# 1964 - 1966 Corvette: Service Bulletin: Gear Shift Control Assembly Buzz

**Source:** Chevrolet Technical Service Bulletin

**Bulletin No:** TSB #66-65

**Date:** June 13, 1966

FIGURE 1

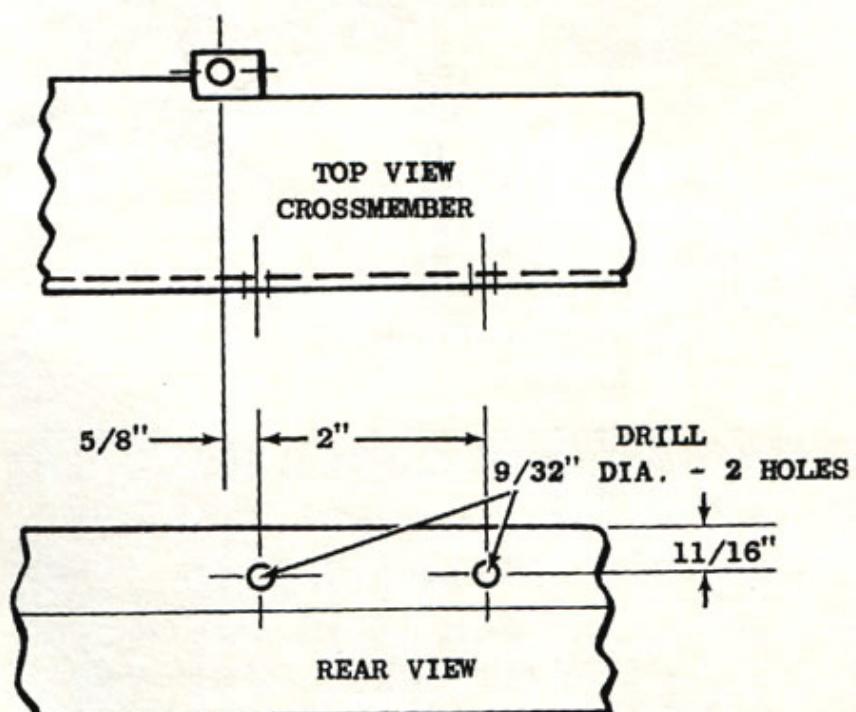
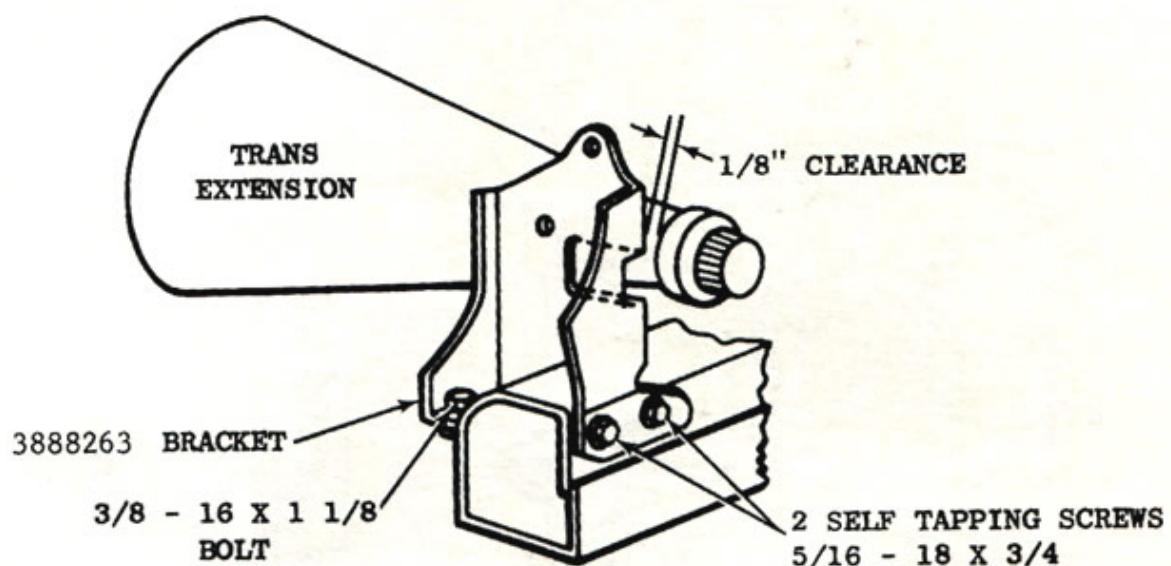
7. Scribe a line 11/16" down from top surface of crossmember on rear side (See fig. 1.)
8. Move new bracket, Part No. 3888263, into position from rear of crossmember.

9. Loosely install bolt through front leg of new bracket through mounting tab on front of crossmember (center in slot). (See fig. 2, item 6.)
10. Using bracket as template, locate position of holes to be drilled at center of bracket slots. (fig. 1)

11. Remove bracket and drill two 9/32" holes in rear of crossmember. (See fig. 1.)
12. Loosely install new bracket using two 5/16" self-tapping screws and washers at rear attachment. (See fig. 2, items 4 and 5.)

15. Reinstall transmission mounting assembly and bracket and exhaust support. Tighten all bolts securely with exception of bolt holding new bracket.
16. Adjust new bracket laterally to provide desired 1/8"\*\* clearance between transmission extension and bracket, then tighten bracket

screws securely. (See fig. 1.)

\* Clearance in excess of 1/8" may cause binding in reverse operation.

FIGURE 2

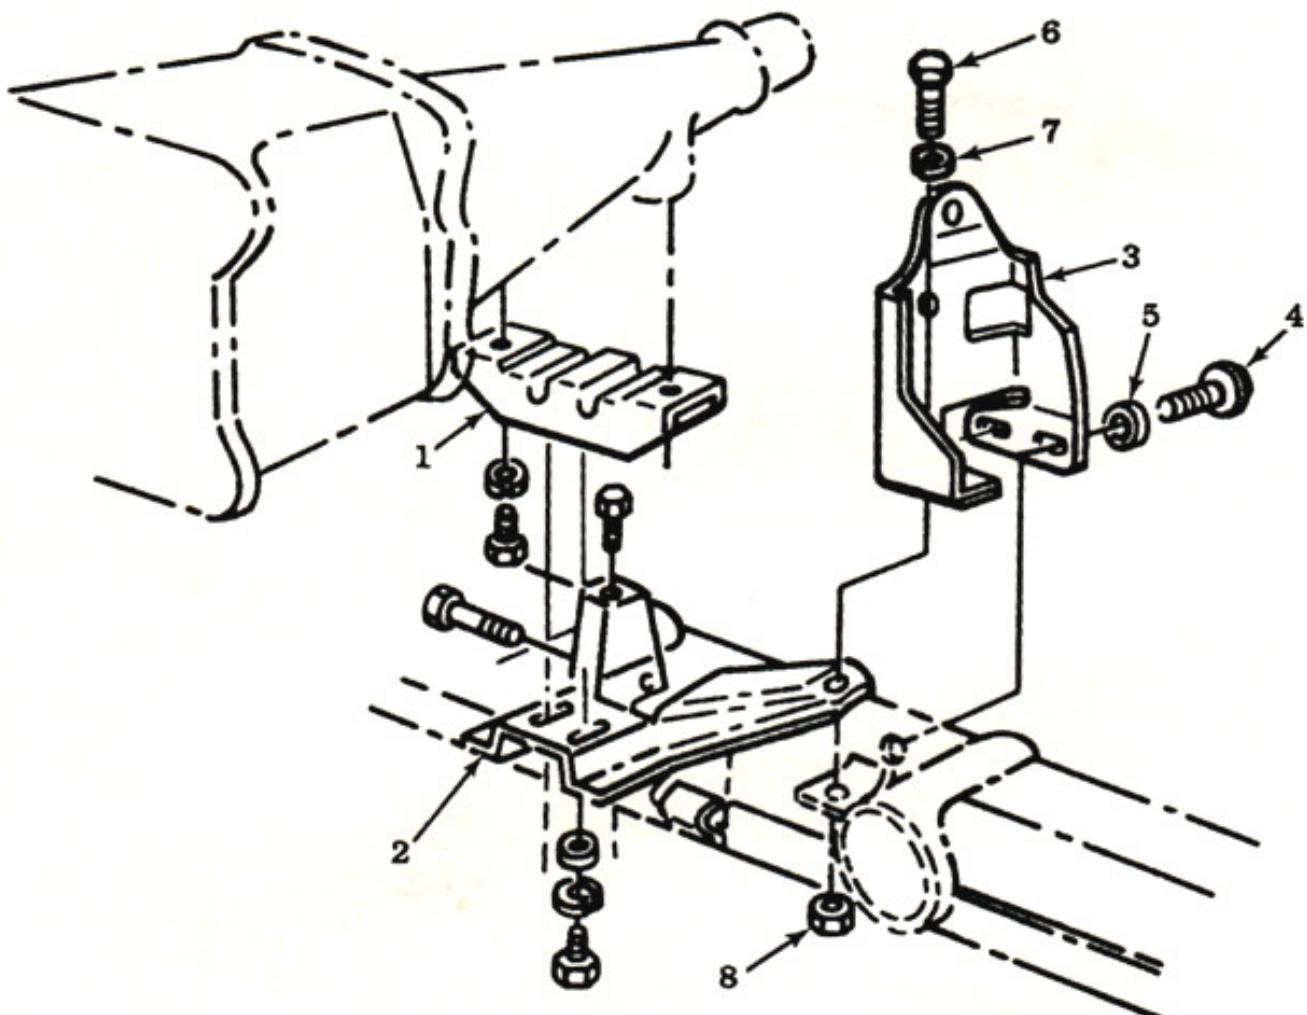
1. Remove shift levers at transmission.
2. Position jack stand under transmission and remove transmission mounting assembly and bracket. (See fig. 2, items 1 and 2.)
